**Re: NPRM 1203OS Extended Diversion Time Operations – Proposed Amendments to CAO82.0**

The Australian and International Pilots' Association (AIPA) is grateful for the opportunity to comment on CASA's *Notice of Proposed Rule Making 1203OS Extended Diversion Time Operations – Proposed Amendments to CAO82.0* and the accompanying draft *Civil Aviation Advisory Publication (CAAP) 82-1(1)*.

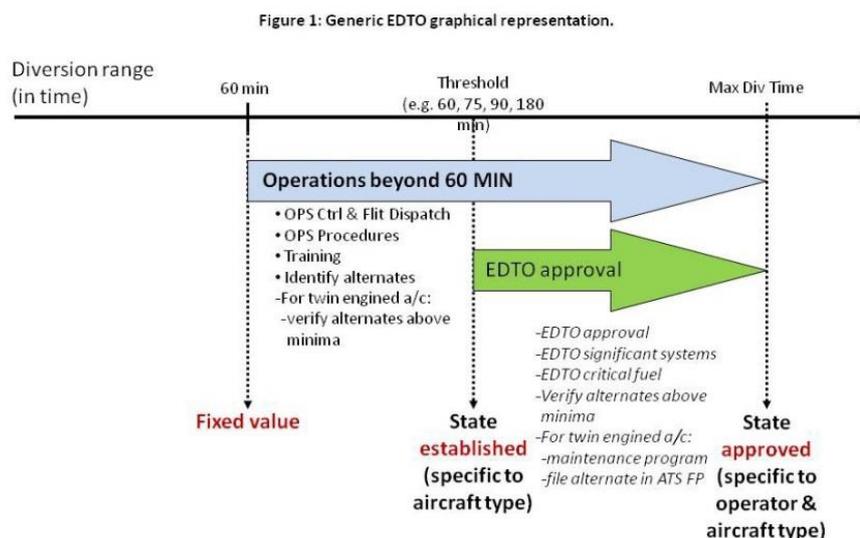
That mechanism as shown in ICAO’s pictorial presentation, clearly does **not** require the EDTO threshold to be set at 60 minutes:

In short, Australia could have established twin-engine 75 minute EDTO thresholds for pistons and 90 minutes for jets and met the ICAO SARPs. However, CASA has chosen to go back to straight 60 minutes for everything with two engines. By way of contrast, the FAA does not require type design EDTO approval for less than 75 minutes, while EASA does not require type design EDTO approval for less than 90 minutes.
